Access Compliance Report

Public Rights-of-Way

(Pedestrian Signals)

Intersection ID: N/A	Main Street:	Cross Street: N/A	Location: N/A
ADA ID: F8C2ED3DBF83	Signal Type: Two Push Buttons-Non APS	Overall Compliance: No	Severity Score: BTN 1:N/A BTN 2: N/A No BTN: N/A
Codes/Mitigation Info/Possible Solution		Field Measurements/Component Compliance

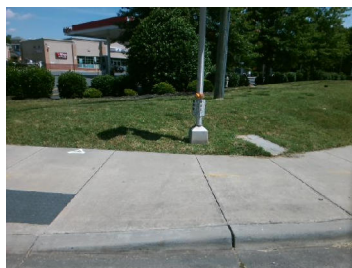
Surveyor Notes: TEXT HT 1/2

PROW/ADA: R410.6, TMUTCD 4e.08, R404.1, R406.2, R404.7.3

Possible Solutions: Replace Signal Push Button With APS Button on New Post. Remove & Replace Sign.
